Re: St. Lucie Plant Unit 2
Docket No. 50-389
Renewed Facility Operating License No. NPF-16

Response to NRC Reactor Systems Branch and Nuclear Performance Branch Request
for Additional Information Regarding Extended Power Uprate License Amendment
Request

RAI 2.8.5.6.2-1

Figure 1 - Total SG Liquid Volume vs. Time

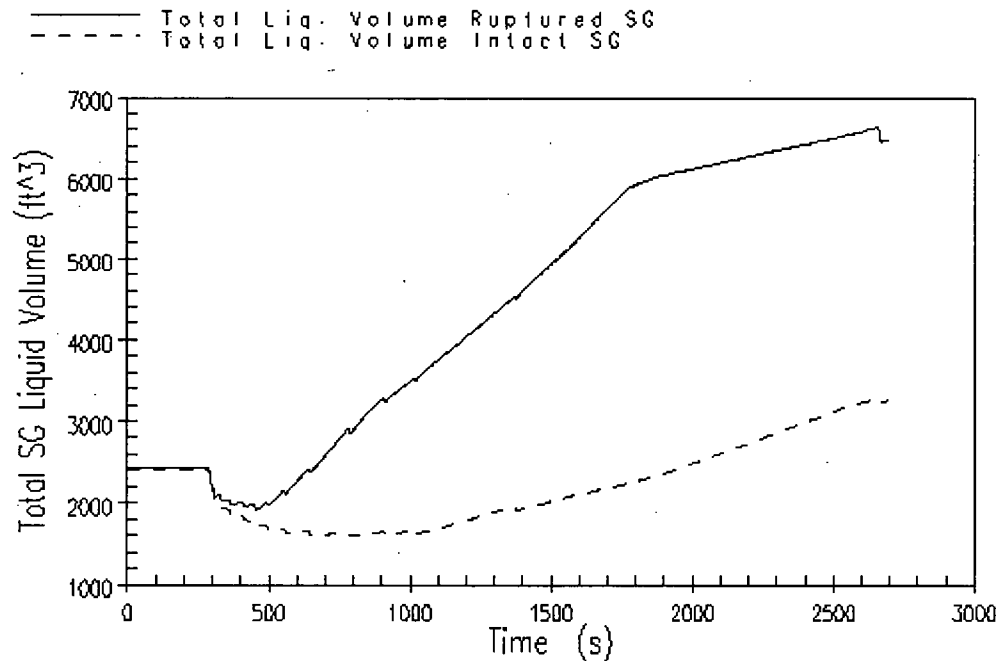
Perform an analysis to show that the SG MTO exists. Confirm that the computer code and methods used in the analysis are approved by the NRC, and address compliance with restrictions and conditions specified in the NRC safety evaluation report approving the computer code and methods. The requested information should include:

The results of the analysis provided below demonstrate that SG MTO exists for St. Lucie Unit 2.

The sequence of events is presented in Table 1. Figure 1 shows the SG liquid volume as a function of time. The maximum SG liquid inventory is calculated to be 6631 ft³, which is below the SG overfill limit of ~7984 ft³, providing a margin of greater than 1,200 ft³ to SG overfill.
